Product Change Notification (PCN)

Date: 03.02.2022 No.: t-1468

TQ2 Relay series

Notification for unification of the safety standard certification : C-UL standard

4. Contents of change

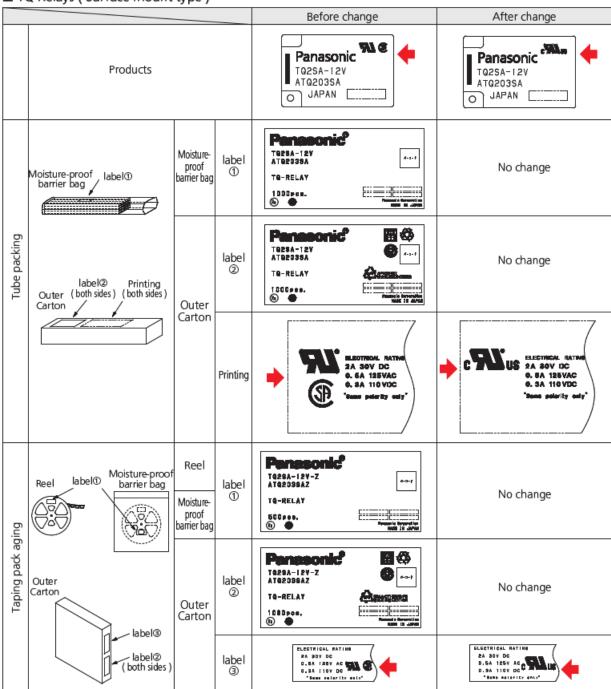
1. Reason for change

To be unified with C-UL standard in accordance with the CSA standard renewal.

■ TQ Relays

■ TQ Relays (Surface-mount type)

Part (Type) number, specification and price remain unchanged
